Project	IEEE 802.16 Broadband Wireless Access Working Group < http://ieee802.org/16 >	
Title	Complementary document for draft comments	
Date Submitted	2003-10-31	
Source(s)	<p>Yossi Segal Itzik Kitroser Yigal Leiba Zion Hadad Runcom Technologies Ltd. 2 Hachoma St. 75655 Rishon Lezion, Israel</p>	<p>Voice: +972-3-9528440 Fax: +972-3-9528805 yossis@runcom.co.il itzikk@runcom.co.il yigall@runcom.co.il zionh@runcom.co.il</p>
	<p>Avi Freedman Hexagon System Engineering 21c Yegi'a Kapa'im st. P.O. Box 10149 Petach Tikva, 49001 Israel</p>	<p>Voice: +972-3-9224420 Fax: +972-3-9224396 avi@hexagonltd.com</p>
Re:	Contribution elaborating on comments for letter ballot #13	
Abstract	This document includes text referenced in several comments given for ballot 13	
Purpose	To be integrated into P80216-REVd_D1 document	
Notice	This document has been prepared to assist IEEE 802.16. It is offered as a basis for discussion and is not binding on the contributing individual(s) or organization(s). The material in this document is subject to change in form and content after further study. The contributor(s) reserve(s) the right to add, amend or withdraw material contained herein.

Complementary document fo

Figure 246a— Channel Coding Process for regular and repetition coding transmission

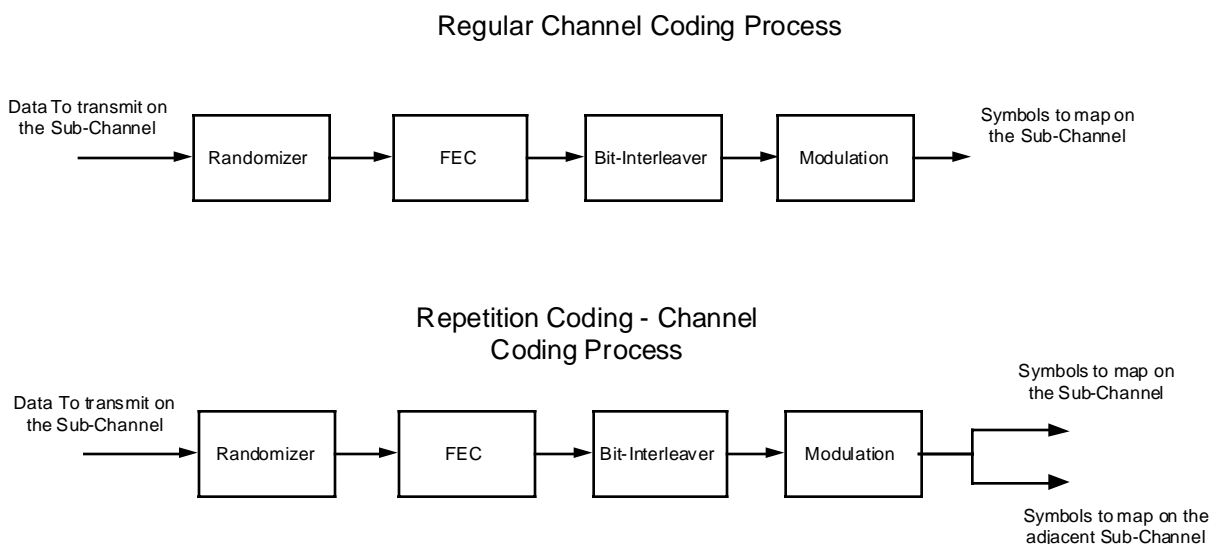
When repetition code is used, allocation for the transmission shall always include an even number of adjacent Sub-Channels. The basic block shall pass the regular coding chain where the first Sub-Channel shall set the randomization seed used in section 8.5.9.1, and the data shall follow the coding chain up to the Mapping. The data outputted from the modulation (section 8.5.9.4) shall be mapped onto the block of sub-channels allocated for the basic block and then it will be also mapped on the following consecutive allocated Sub-Channels (for repetition coding of 2 another block of sub-channels of the same size is used, while for repetition coding of 4 another 3 blocks of sub-channels of the same size are used), the process of regular encoding and repetition encoding is shown in figure 246a
